Appendices to analysis of the water-quality standards proposed by Nevada Division of Environmental Protection

Errata Sheet for ANALYSIS OF THE WATER-QUALITY STANDARDS PROPOSED BY
THE NEVADA DIVISION OF ENVIRONMENTAL PROTECTION, Submitted by the
City of Las Vegas, August 1987

EVALUATION OF PROPOSED STATE OF NEVADA
WATER QUALITY STANDARDS FOR AMMONIA

PRODUCED BY CH2M HILL CALIFORNIA
FOR CLARK COUNTY

Figure 8-53 Simplified Bay Surface Layer Dilution Schematic

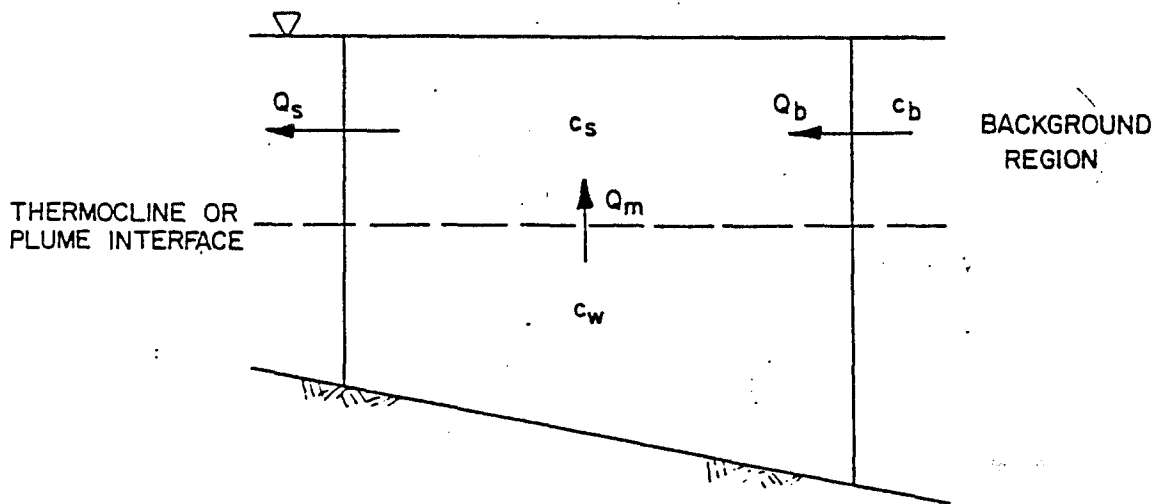
BC Figure 8-53 (shown in Attachment 1) is mislabeled. What BC calls c(w), the concentration at Northshore Road, is actually one of several hypolimnetic concentrations at Station "s". It must be correctly labeled c(sh), not c(w). BC's mislabeling is a consequence of the underlying assumption that lake water is not entrained into the plume -- that is, that the plume does not become increasingly dilute as it moves through Las Vegas Bay. This assumption is false.

The dilution-ratio formula is what mathematicians call deterministic. The relations among $c(w)$, $c(s)$, and $c(b)$ are assumed to be completely determined by the simplified model shown in Figure 8-53 on p. 8-103, and these relations are assumed to be precisely those given in BC's equation (6).

In order to correspond correctly with conditions in the lake, it must be modified as follows:

Figure 8-70 Bay Surface Concentrations, Stations 2, 3, and 4, Versus Wash Input Concentrations, Specific Conductance

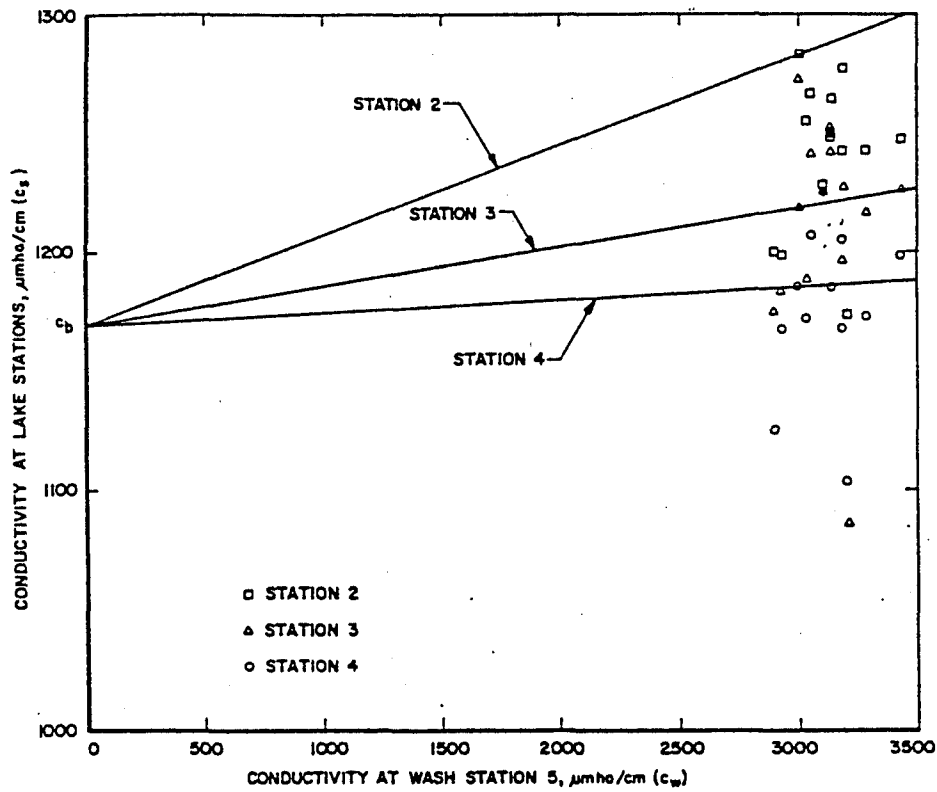
The principal error was the inclusion of a falsely plotted point: "the intercept should be approximately $c(b)$, the background concentration". Look carefully at Figure 8-70 on p. 8-153 (Attachment 2). Notice that $c(b)$ has a Y value of approximately 1175 micromhos/cm, but the X value associated with that Y value is zero. The conductivity at Wash Station 5 was never anything remotely approaching zero. The $c(b)$ value of 1175 is properly associated with a wash conductance of approximately 3200. When this point is correctly plotted at $Y = 1175$ and $X = 3200$, it falls smack in the middle of the highly scattered values for $c(s)$. Without the falsely plotted value of $c(b)$, there is nothing but hopeless scatter in the region

We have singled out conductance for analysis because it gave the highest values of r^2 according to BC: 0.65 at Station 2 and 0.64 at Station 3. The r^2 at Station 4 fell to 0.16 not because "Lower values were found at the outer stations where physical conditions contribute to greater variability", as BC explained on p. 8-151. Figure 8-70 shows that the scatter for Station 4 points was no greater than the scatter for Station 3. The value of r^2 fell at Station 4 only because the average conductance at Station 4 was nearly equal to the average conductance at Station 8; consequently, the regression line had almost no slope. The higher values of r^2 at Stations 2 and 3 are purely an artifact arising from the difference between the average background conductance (about 1175) and the average conductance at the inner bay stations. Remove the falsely plotted point for c(b) or plot it correctly at $X = 3200$ rather than at $X = 0$ and the high values for r^2 vanish. Furthermore, the difference in slope between the regression lines for Stations 2 and 3 is exaggerated because the regression line for Station 2 has obviously been misplotted. Only the single highest value for Station 2 falls on the line; all the other points -- excepting the falsely plotted point for c(b) -- lie well below the so-called regression line in BC figure 8-70.

Figure 8-70 is not a fair representation of the true scatter because all the points shown are claimed to be "average monthly data" (p. 8-151). The monthly averages hide all the scatter measured during the month. For example, surface conductance at Station 2 ranged from 1060 to 1250 in April 1980, from 1130 to 1370 in May 1980; in 1985 the scatter was no better: 1030 to 1250 at Station 2 in May, 1100 to 1400 in June. Bad as the scatter

is in Figure 8-70, much of the true scatter is hidden by BC's having plotted only the monthly averages rather than the actual daily readings. The instabilities shown in these scatterplots are concrete evidence that deterministic models are out of place in dealing with these data.
